**Project:** I-405/Brickyard to SR 527 – Improvement Project  
**Contract No.:** 009727

**Subject:** Supplement to Notice of Protest 014 – NB405 Bridge 405/103E Widening – ATC-1 Interpretation

**Re: I-405/Brickyard to SR 527 Improvement Project (the "Project")  
AECOM Project No. 60713342  
Notice of Protest Supplemental Information  
PCN-00080 – Bridge 103E Widening**

Figure 1 – ATC01 Design Approach at Pier 3

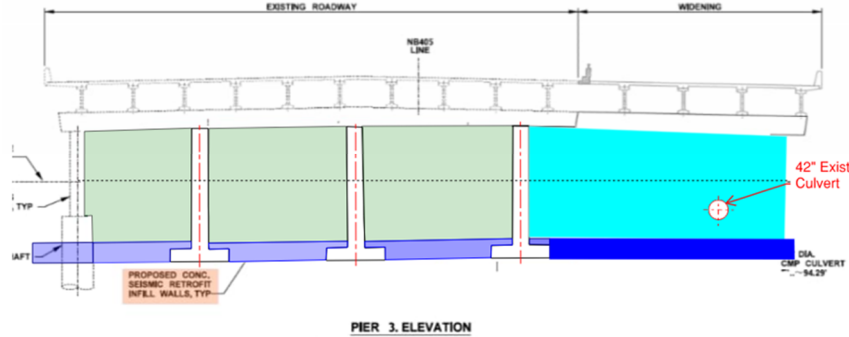
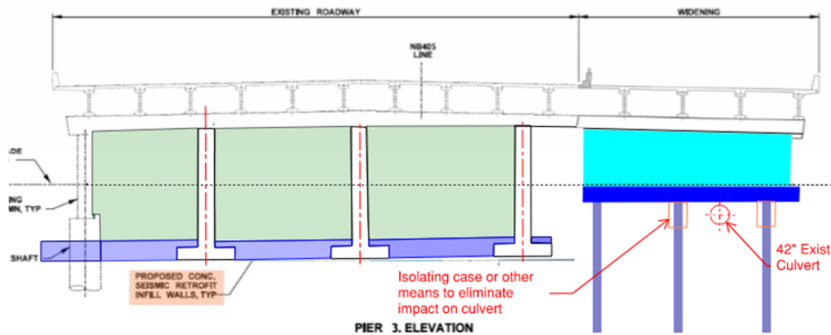
In response to the revised site conditions and aim to resolve WSDOT concerns, AECOM developed eight design alternatives and conducted a Type-Selection Workshop with WSDOT on October 22, 2025. During the workshop, AECOM presented a detailed analysis for each option and specifically outlined the following key disadvantages of Option 2 (ATC-1 as interpreted by WSDOT, see Figure 1) when compared with Option 3 (the DB team’s proposed design that follows the ATC-1 agreed approach when incorporating the updated geotechnical information, see Figure 2):

1. Code requirements

BDM 15.2.10 states, “the design of the widening shall conform to current standards and not the standards used to design and construct the existing structure.” Under the ATC-1 approach as interpreted by WSDOT, the widened portion would introduce in-ground plastic hinges, which are difficult to access for inspection and would result in significant post-earthquake repair and maintenance challenges.

2. Traffic impacts on 228th Avenue

Combining the existing footing with the new footing requires a closure strip. Installing this closure strip necessitates excavating and leaving open a footing trench, resulting in substantial disruption to 228th Avenue and would likely make it difficult—or even impossible—to maintain two operational traffic lanes during construction.

3. Protection of the existing culvert

The existing culvert is aged, has no as-built documentation, and is expected to be fragile. The ATC-1 concept as interpreted by WSDOT involves excavation beneath the culvert, which would significantly disturb it and introduce a high risk to its structural integrity during construction.

4. Extended construction duration

ATC-1 as interpreted by WSDOT requires a longer and more complex construction sequence, resulting in prolonged impacts to local traffic and greater disruption to the surrounding community.

Figure 3 – I-405 Mainline Bridge Over Talbot Road

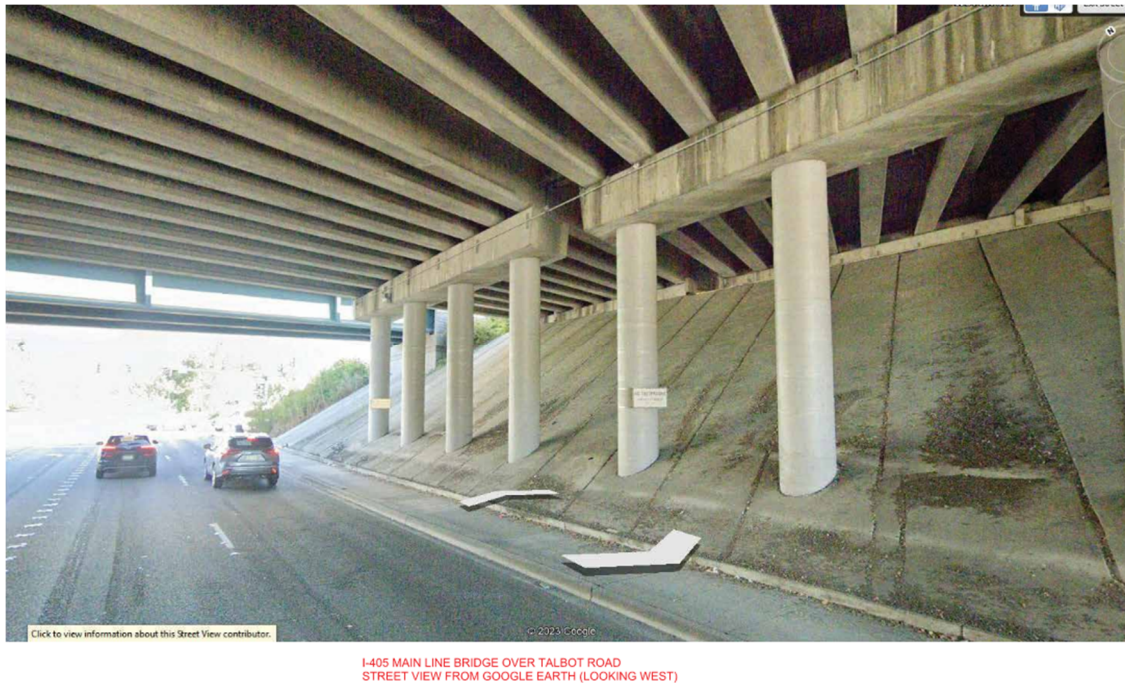
This practice is also observed in WSDOT structures. As shown in Figure 3 (I-405 Main Line Bridge over Talbot Road), the existing bridge and the widened portion utilize separate substructures, supporting the appropriateness of the Design-Build team’s proposed approach.
